Applicant : Gordon W. Breuker et al.
Appln. No. : 10/600,777
Page : 18

REMARKS

FIG. 5

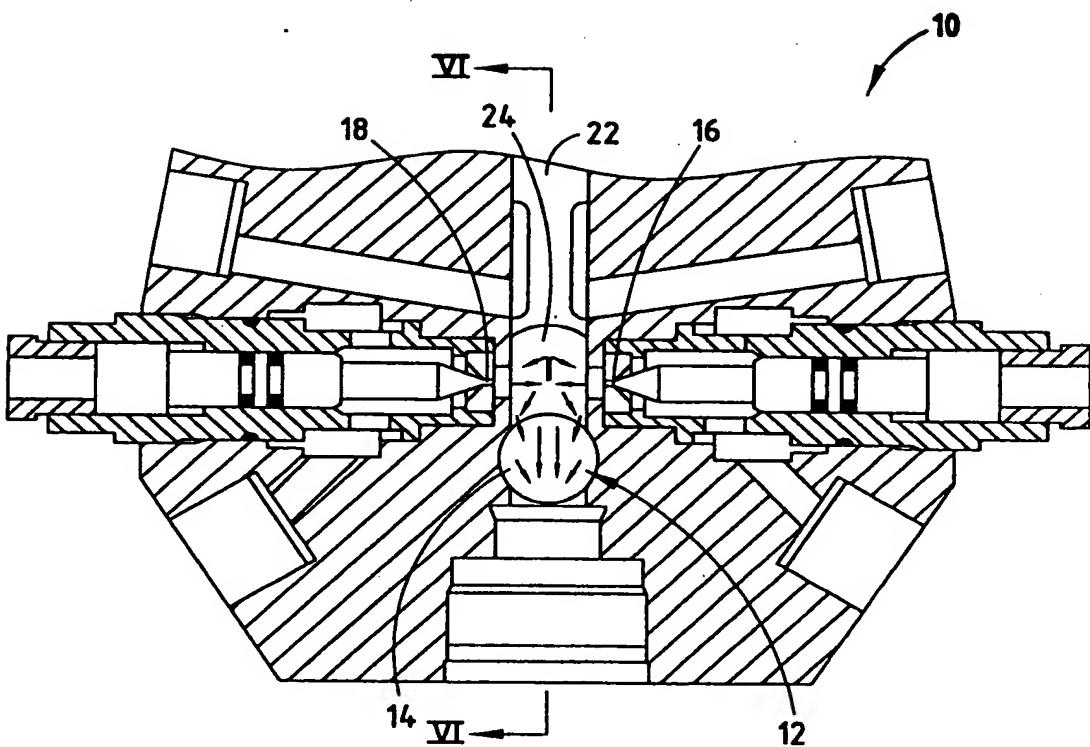
The drawings have been objected to for not containing the legend "Prior Art" in Figs. 5-7. Applicants have added the legend "Prior Art" to Figs. 5-7 and submit that the objection to the drawings is now obviated.

Prior Art
legend added
